| Well Name: TSAH TAH 3          | Well Location: T24N / R10W / SEC 3 /<br>SENW / 36.346426 / -107.88755 | County or Parish/State: SAN<br>JUAN / NM  |

Notice of Intent

**Planned P & A Procedure**

**CONDITIONS OF APPROVAL**

**Planned Wellbore Schematic**

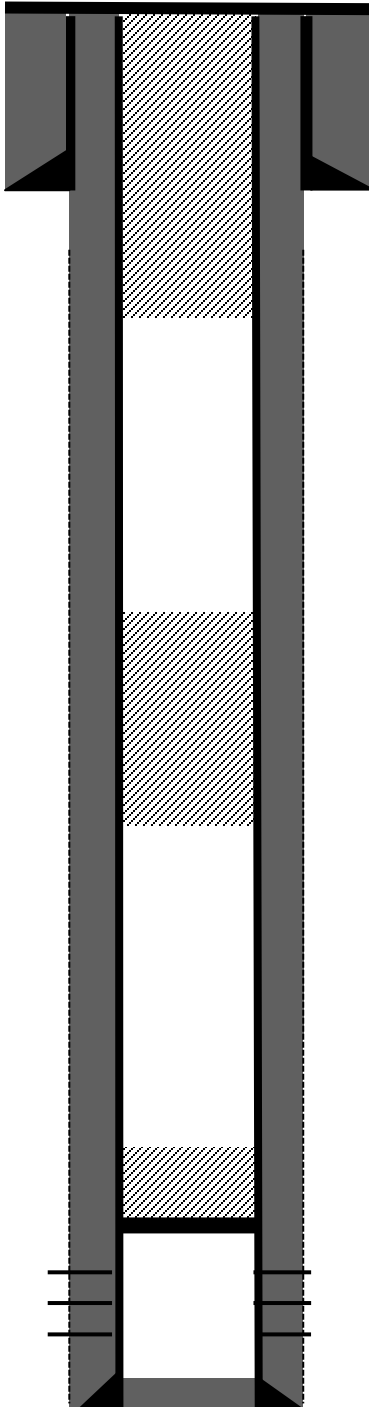
| Created By | Condition  | Condition Date |
|------------|--|----------------|
| mkuehling  | planned schematic shows wrong depth for surface plug - should be 182 feet - Notify NMOCD 24 hour prior to moving on. | 11/6/2023      |
